INTERCOM SYSTEM

87 Beacon Street

To: Nicholas A. Armata, AICP / Senior Preservation Planner
Beacon Hill Architectural Commission

Re: Violation Notice / VIO.23.0641

**HINGED COVER
87 BEACON STREET**

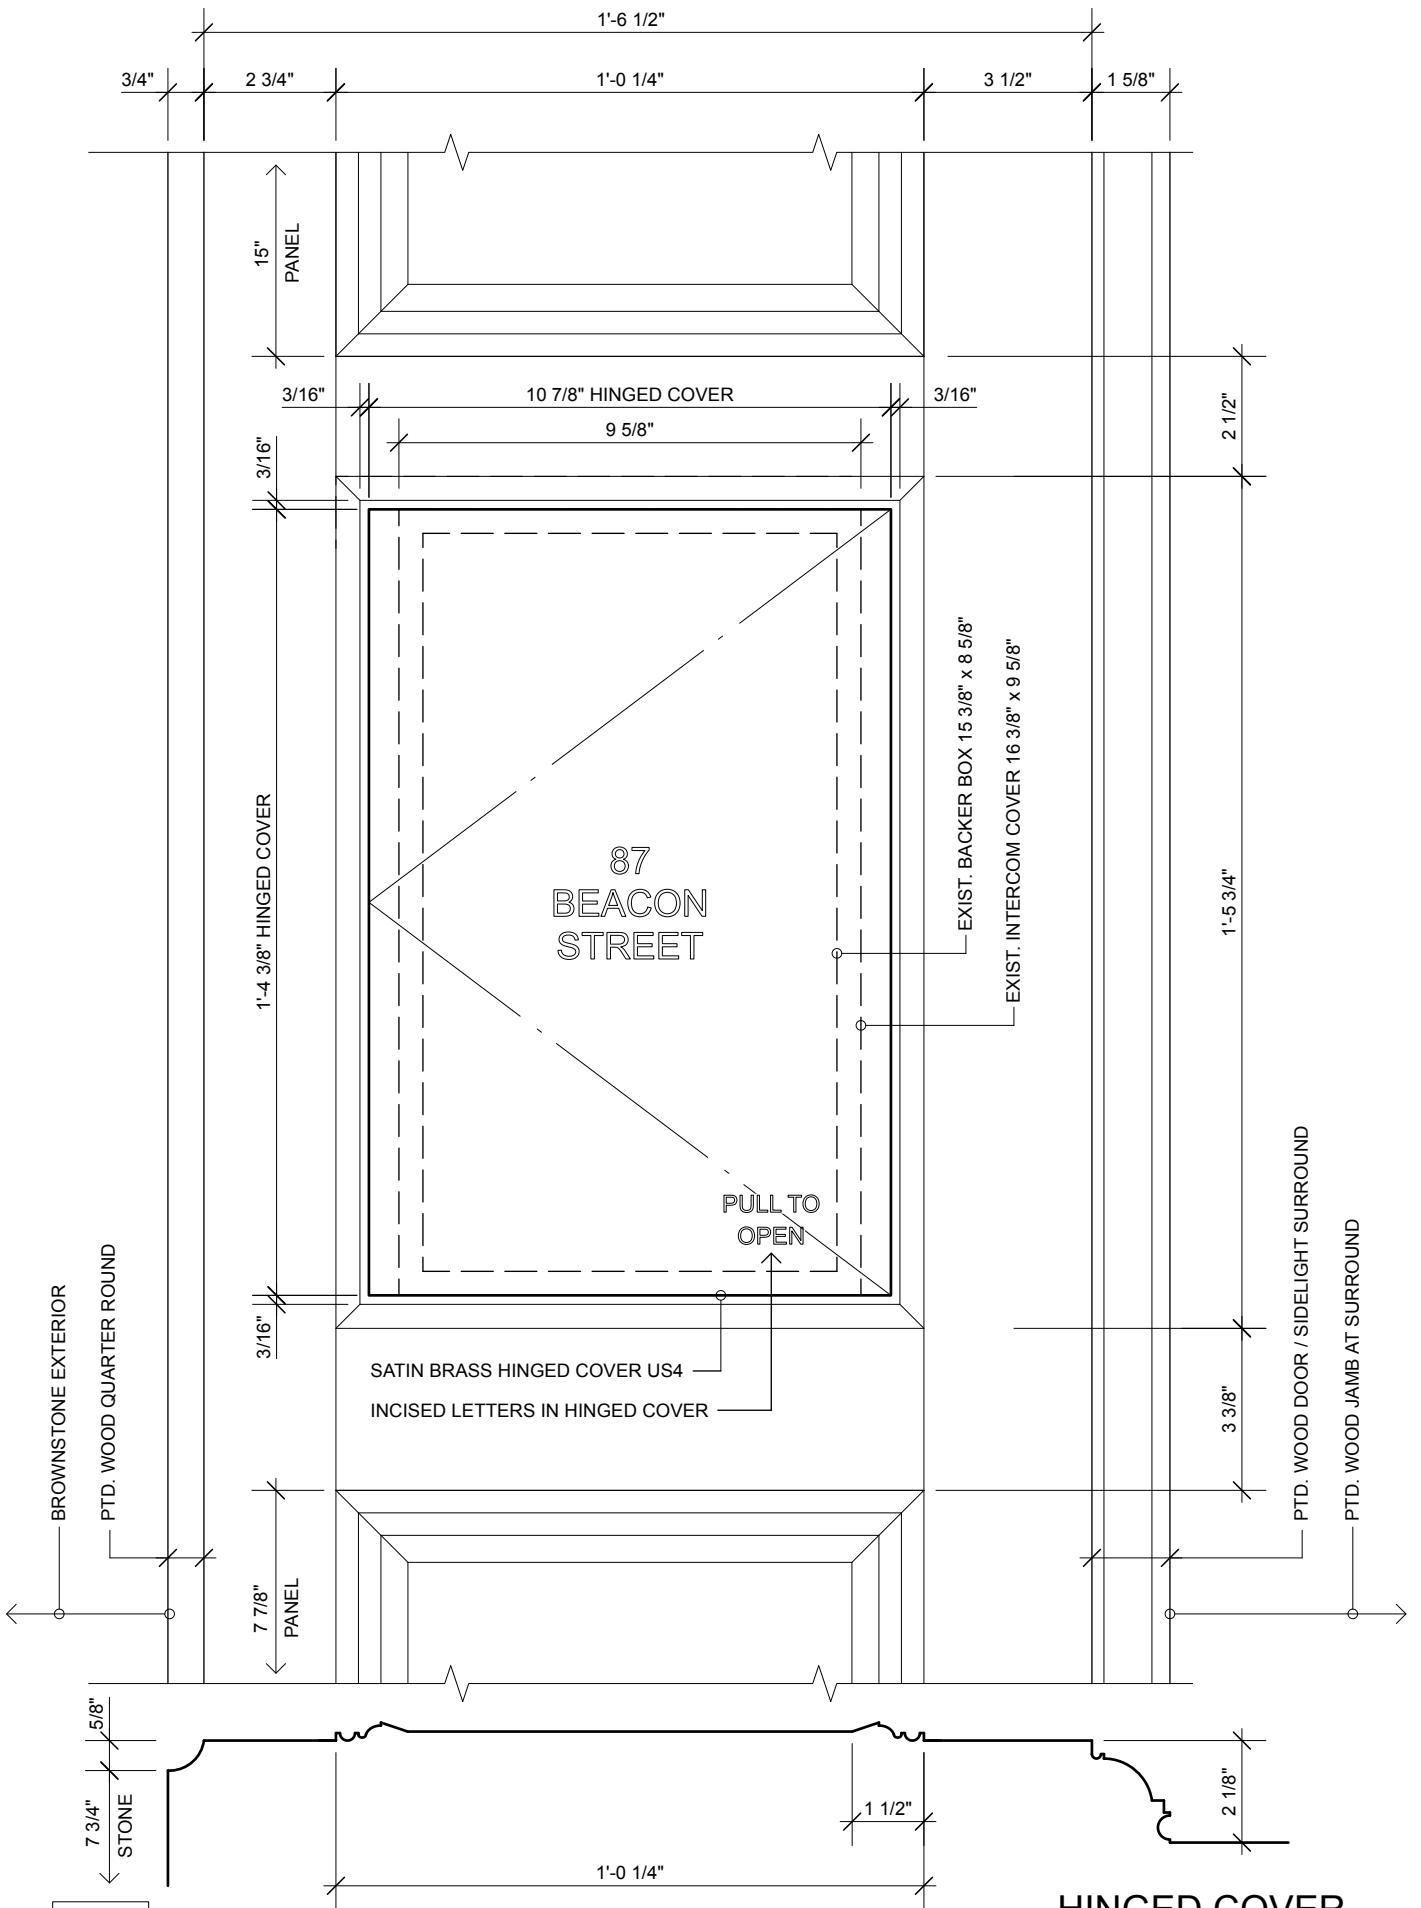
Provide Hinged Brass Cover with Incised Letters of Address to Conceal Intercom

The proposed hinged cover will be fabricated of solid brass and satin finished to conceal the intercom panel. Also, the key keeper in the panel below the intercom will be painted to match the wood. Please let us know if this approach will meet the guidelines in response to the violation notice. If you require any additional information in reference to this project, please contact resident Aileen Benson at 617-513-1108, or via email to aileen_lilith_benson@yahoo.com
